ENGINEERING CHANGE NOTICE

Proj. ECN B-714-53

Block 5: B-714, GROUT VAULT PAIR (218-E-16-102 & 103)(218-E-16-104 & 105)/EDMC
Block 9: ECN B-714-17, B-714-22, B-714-30, B-714-42
Block 8: **AFFECTED DOCUMENTS (Drawings)**

13a. Justification (mark one)	13b. Justification Details
Criteria Change ■ Design Improvement ■ Environmental ☐ As-Found ☐ Facilitate Const. ■ Const. Error/Omission ☐ Design Error/Omission ■	CRITERIA CHANGE to separate Safety Class 2 & 3 wiring; ITEM #'s 6, 7, 17, 22, 23 & 34 (Ref WHC-SD-B714-W-QAPP-001, REV 4) ALL OTHER ITEMS are miscellaneous design improvements, drawing errors, design clarification and ease of construction changes.

KAISER ENGINEERS HANFORD	ENGINEERING CHANGE NOTICE SKETCH					
Ref. Dwg. H-2-78501	Sh. 2	Rev. 0	Prepared By A.R. SNOWHITE	Checked By	ECN No. B-714-53	Page 40/49

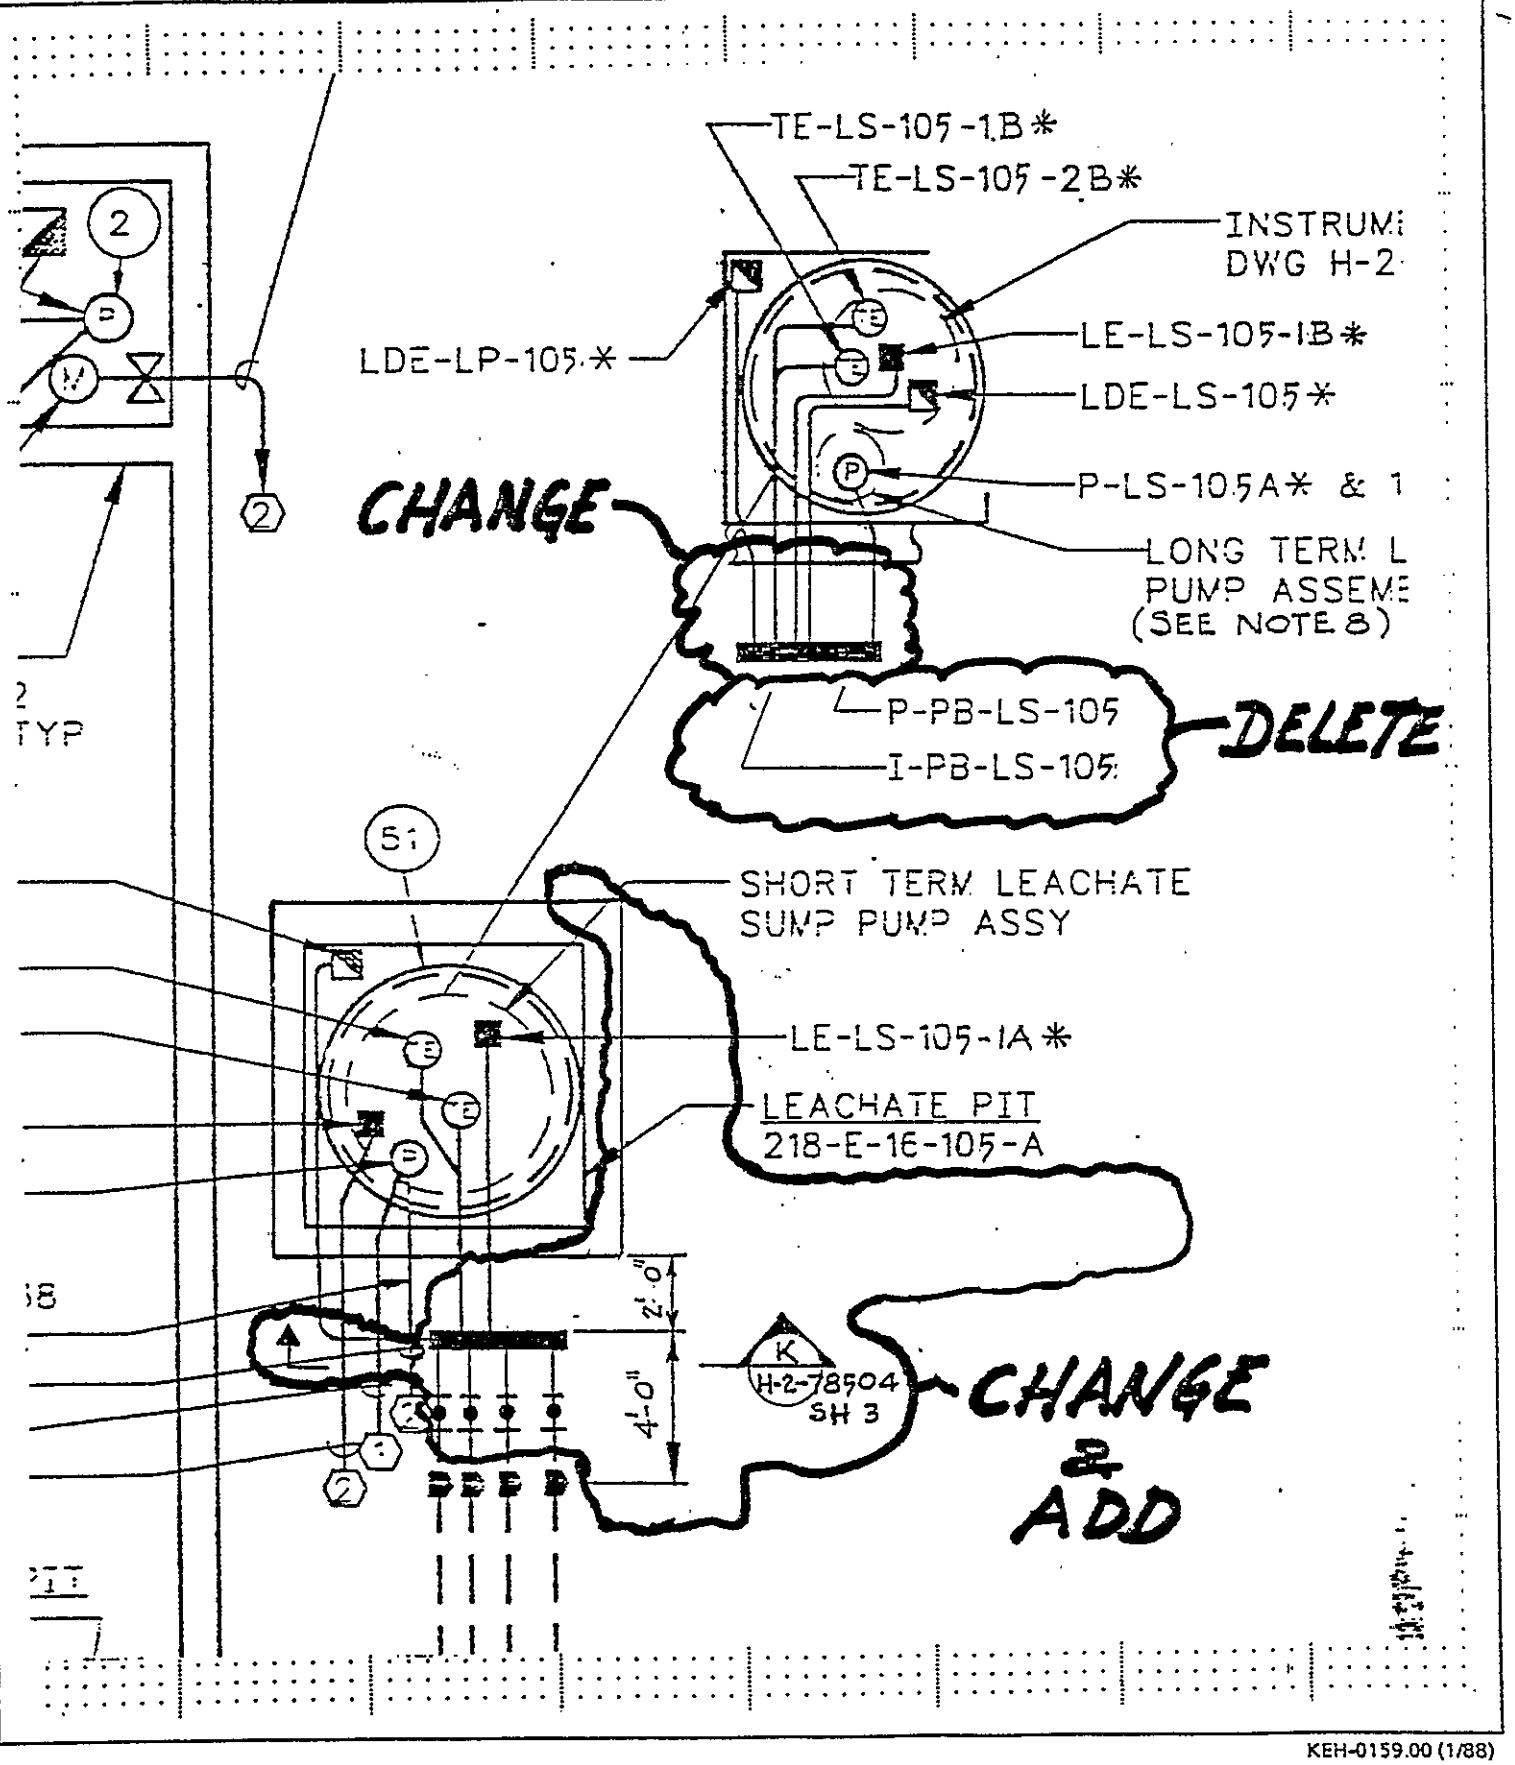
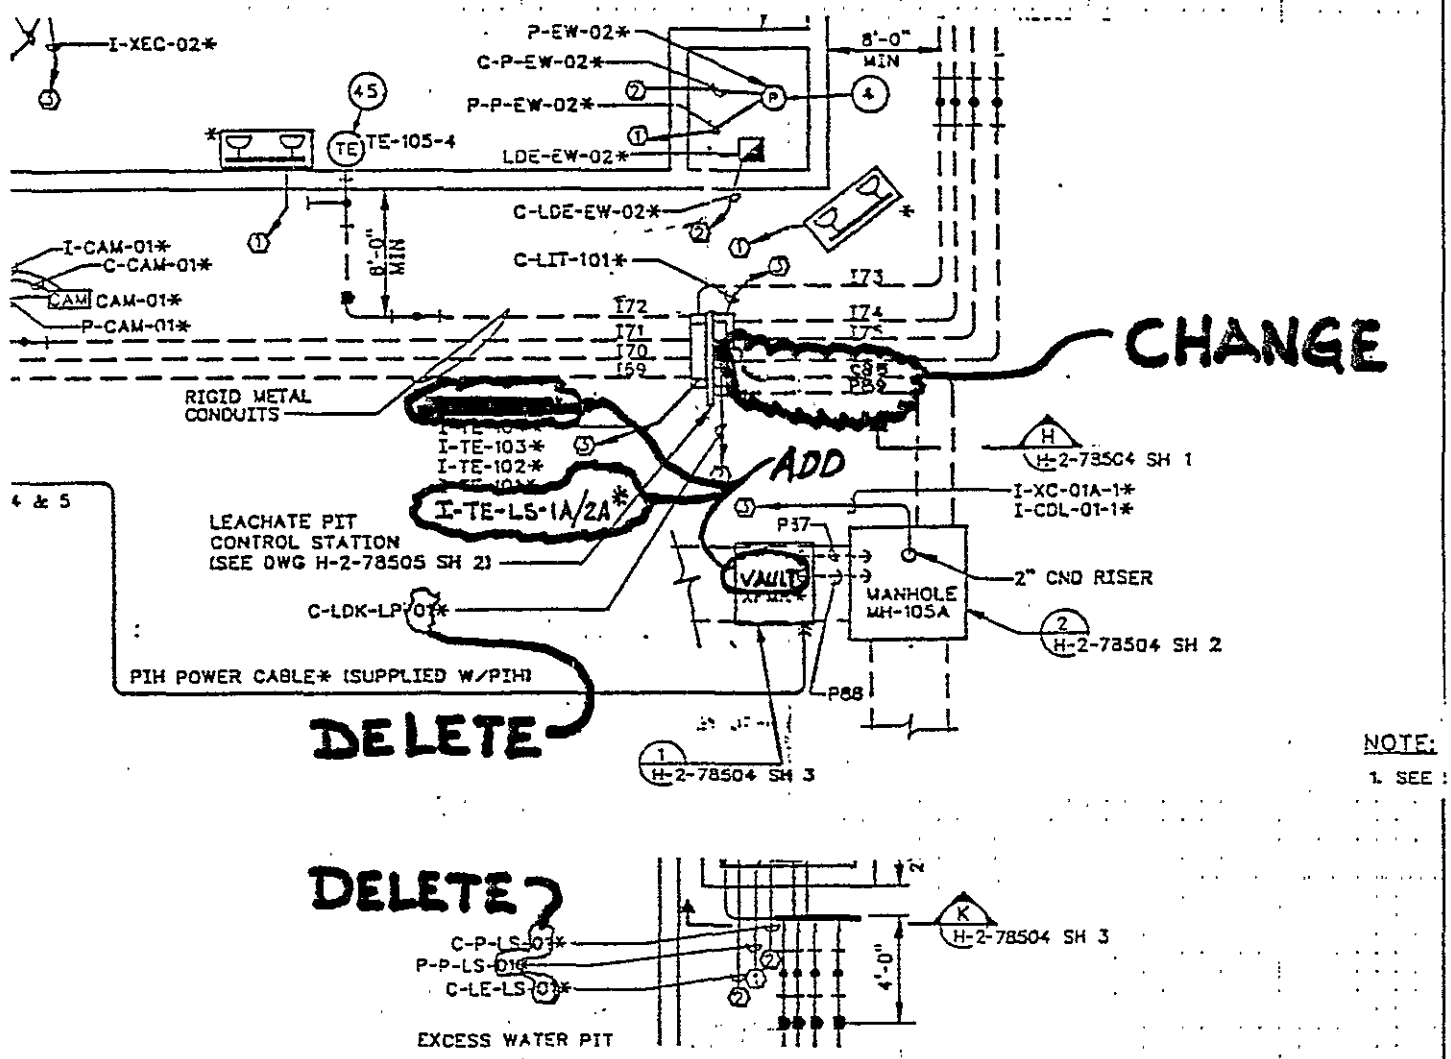
23) H-2-78501, SH 2, REV 0
PLAN (ZD-E2, C3): Modify - see page 40 & 41 of this ECN

KAISER ENGINEERS HANFORD	ENGINEERING CHANGE NOTICE SKETCH					
Ref. Dwg.	Sh.	Rev.	Prepared By	Checked By	ECN No.	Page
H-2-78502	1	0	TK EHRHARD	[illegible]	B-714-53	42/49
H-2-78502	3	0

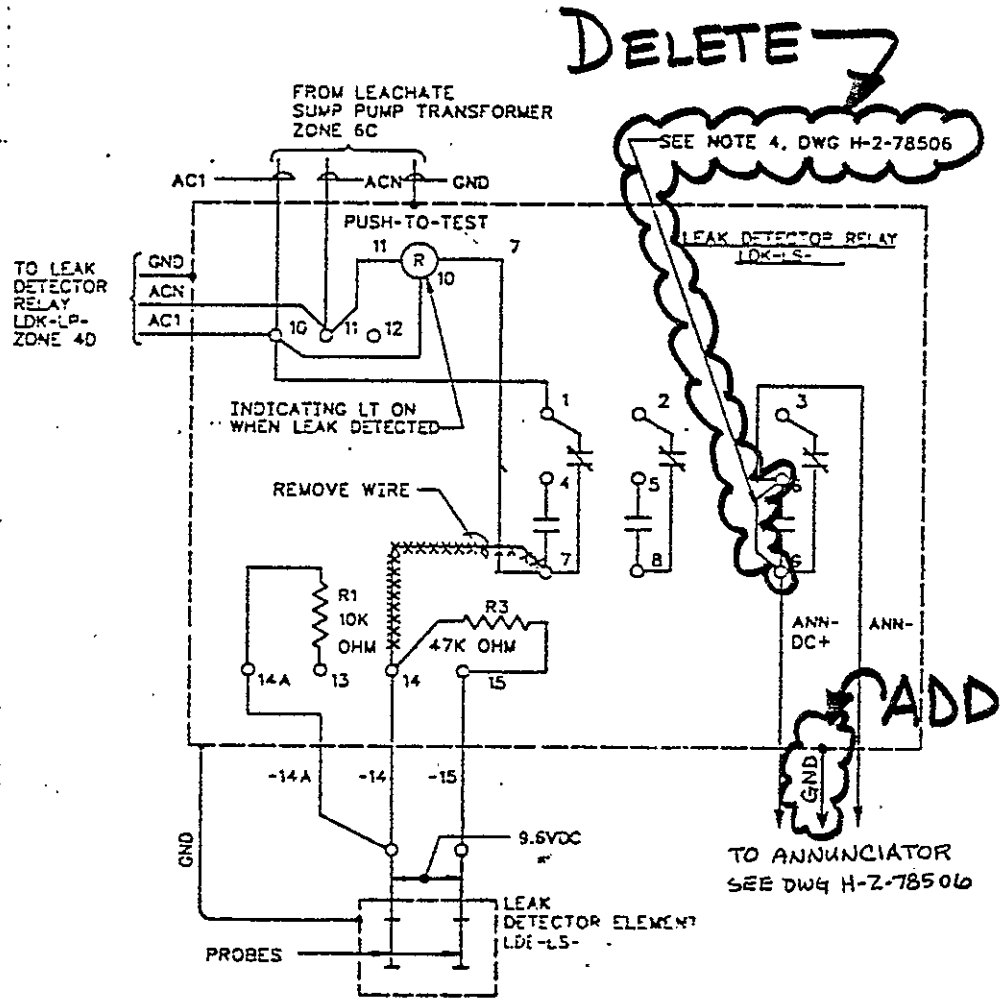
24) H-2-78502, SH 1, REV 0
A) LONG TERM LEACHATE SUMP PUMPS ELEM DIAG (ZC5):
Delete D-PB-01-13C in its entirety
B) LEACHATE SUMP LEAK DETECTION CONN DIAG (ZE2, F2-3):
Modify - see page 42 of this ECN
C) LEACHATE SUMP HIGH-HIGH LEVEL DETECTION CONN DIAG (ZD1):
Modify - see page 43 of this ECN
D) EW DIVERTER VALVE MOV-08 ELEM DIAG (ZA7-F8):
Delete in its entirety by cross-hatching
E) SHORT TERM LEACHATE SUMP PUMP & EXCESS WATER PUMPS (ZC4-F6):
Delete in its entirety by cross-hatching
F) In ZC4 ADD the following note leadered to cross-hatching:
SEE DWG H-2-80976 & H-2-80978 FOR WIRING DIAGRAMS

26) H-2-78502, SH 3, REV 0
A) LONG TERM LEACHATE SUMP PUMPS ELEM DIAG (ZC5):
Delete D-PB-01-13C in its entirety
B) LEACHATE SUMP LEAK DETECTION CONN DIAG (ZD2, E2-F3):
Modify - see page 42 of this ECN
C) LEACHATE SUMP HIGH-HIGH LEVEL DETECTION CONN DIAG (ZD1):
Modify - see page 43 of this ECN

Ref. Dwg.	Sh.	Rev.	Prepared By	Checked By	ECN No.	Page
H-2-78502	2	0	A.R. SNOWHITE		B-714-53	44/49

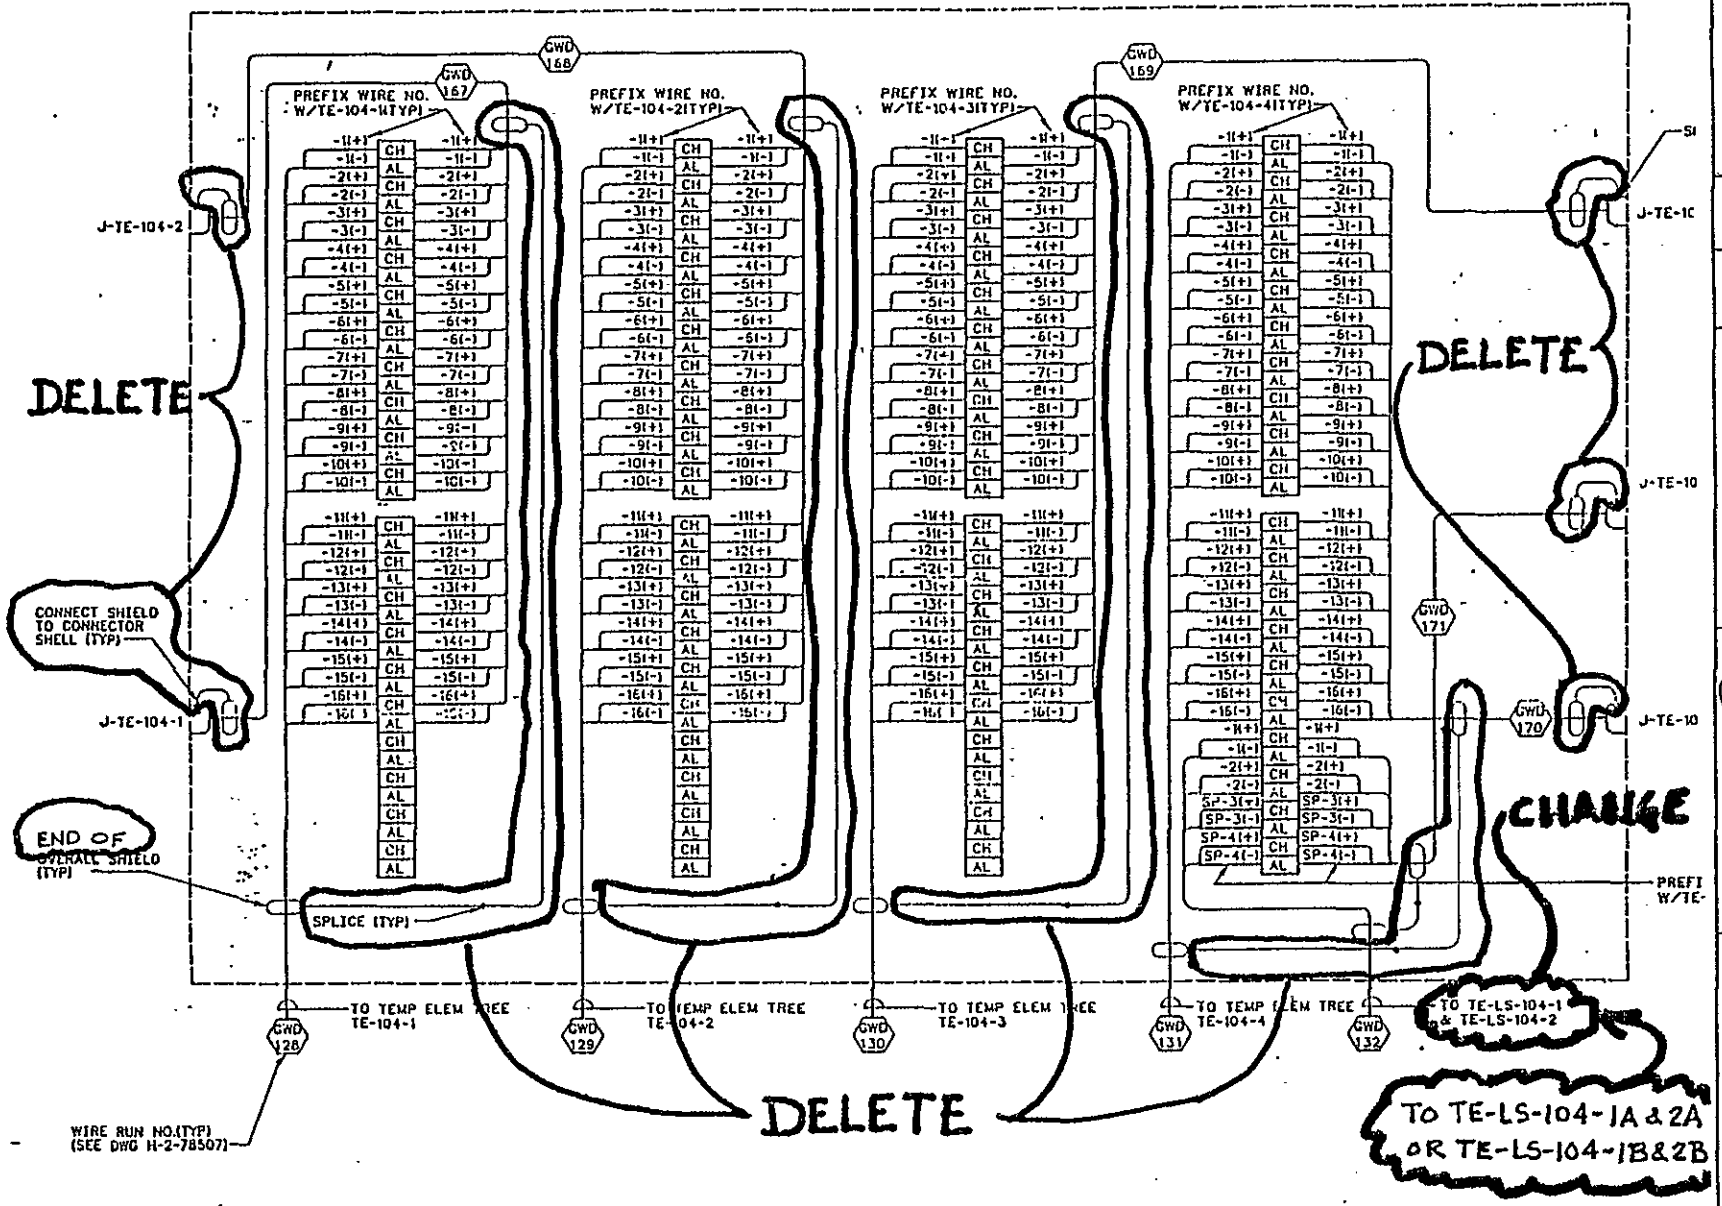
25) H-2-78502, SH 2, REV 0
Modify - see page 44 of this ECN

Ref. Dwg.	Sh.	Rev.	Prepared By	Checked By	ECN No.	Page
H-2-78502	4	0	A.R. SNOWHITE		B-714-53	45/49

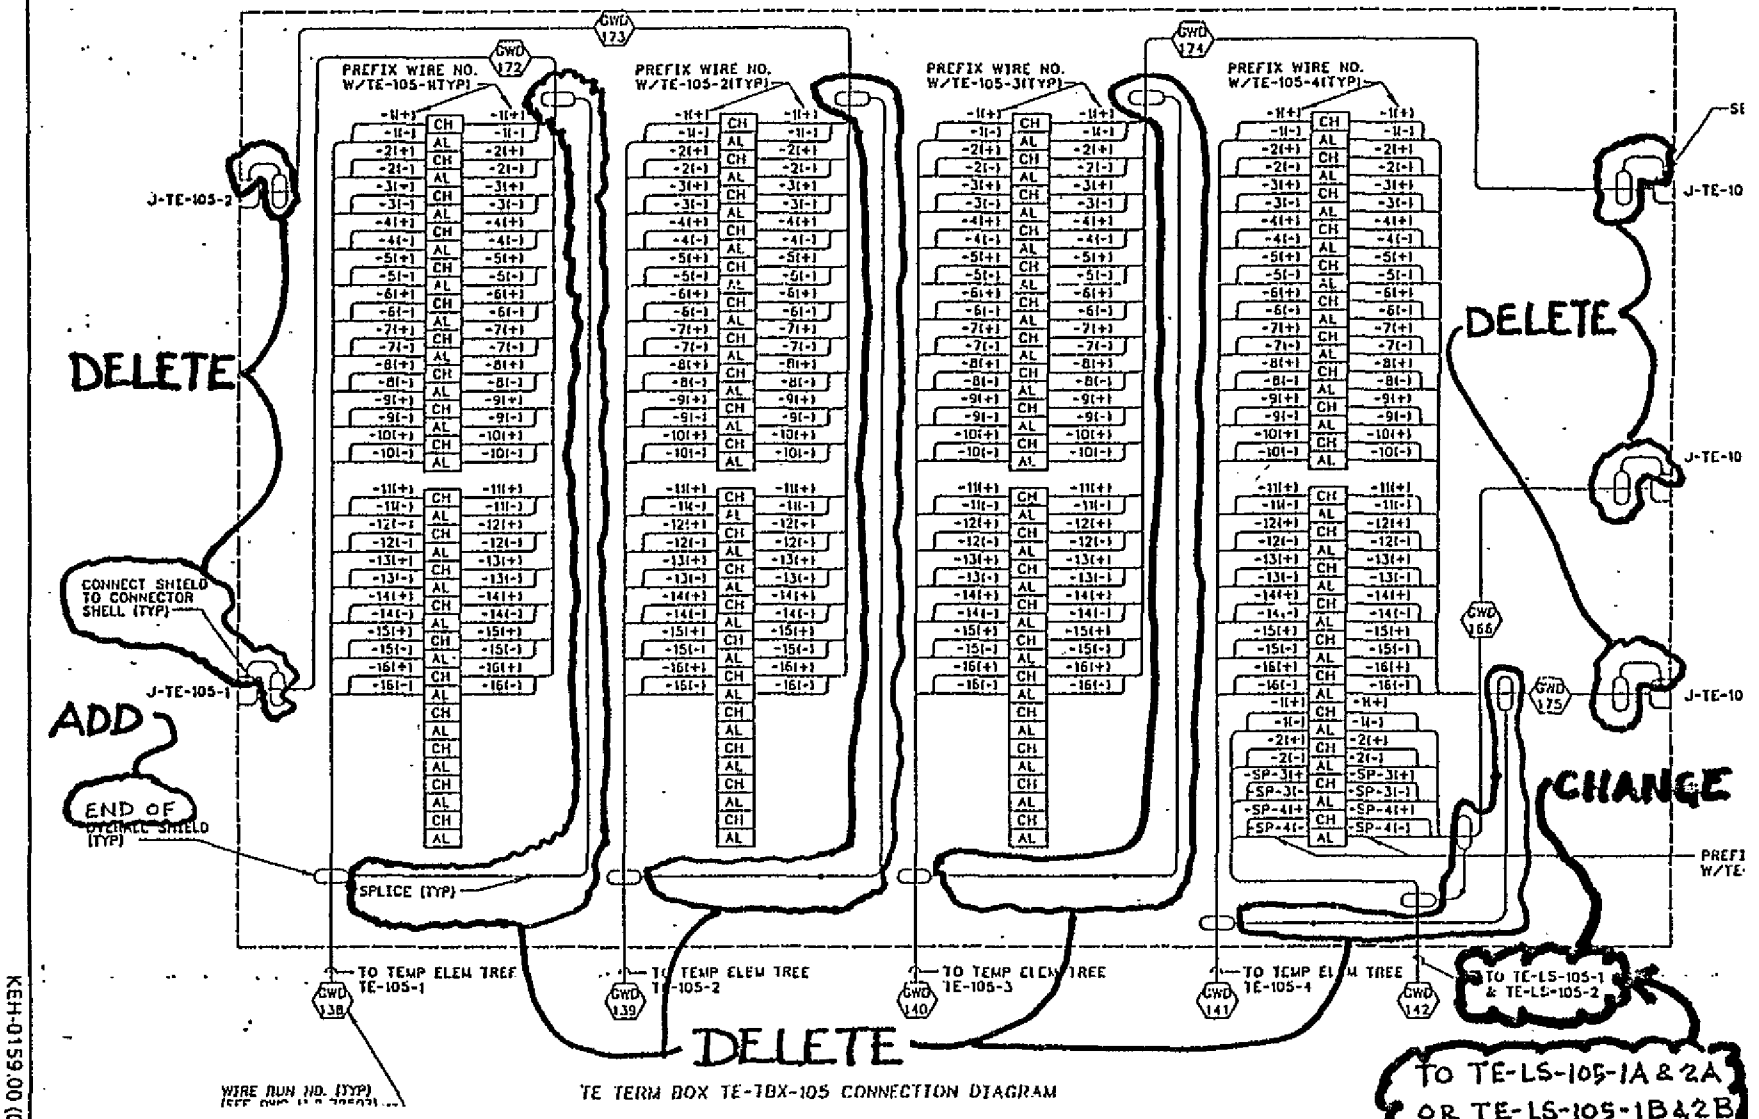
27) H-2-78502, SH 4, REV 0
Modify - see page 45 of this ECN

KAISER ENGINEERS HANFORD	ENGINEERING CHANGE NOTICE SKETCH					
Ref. Dwg. H-2-78504	Sh. 2	Rev. 0	Prepared By A.R. SNOWHITE	Checked By C Dublett	ECN No. B-714-53	Page 49/49

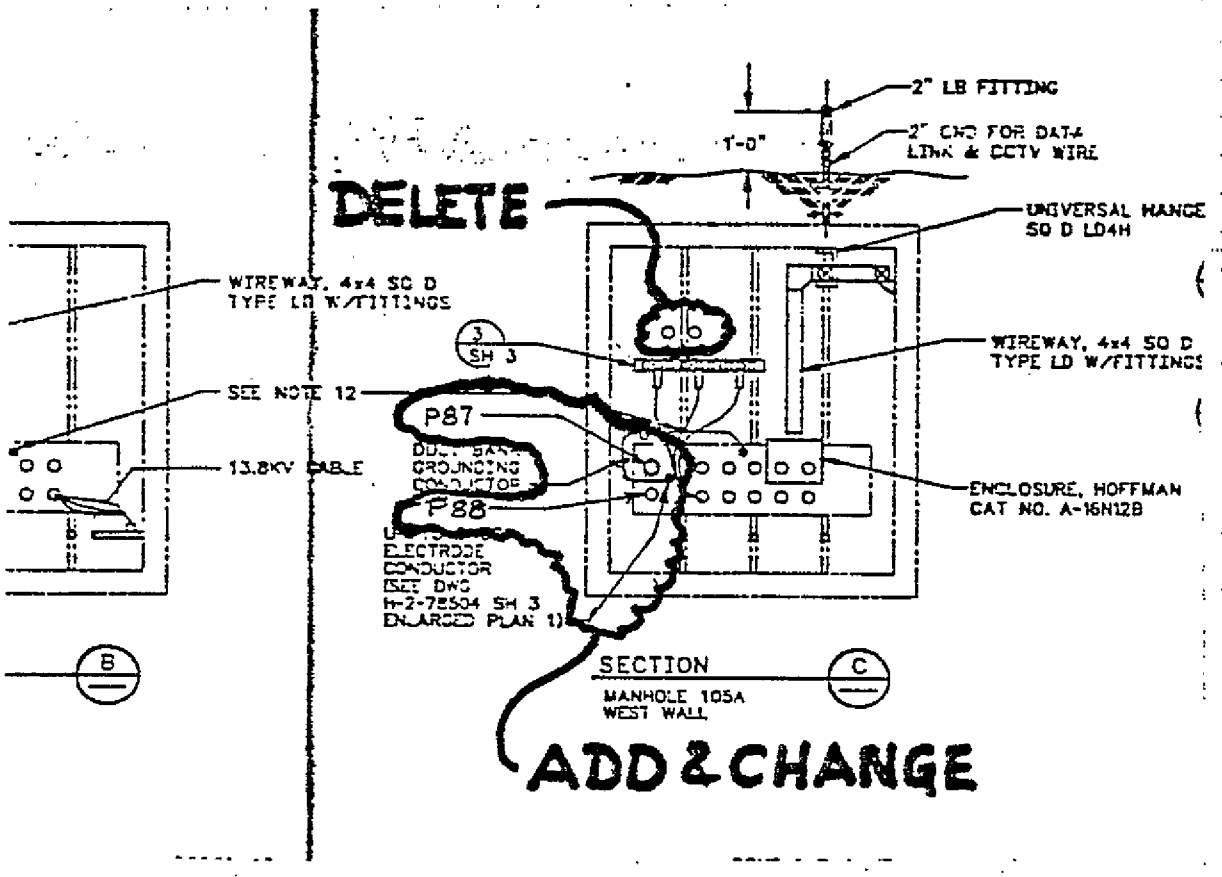
29) H-2-78504, SH 2, REV 0
SECTION C (ZC5): Modify - see page 46 of this ECN
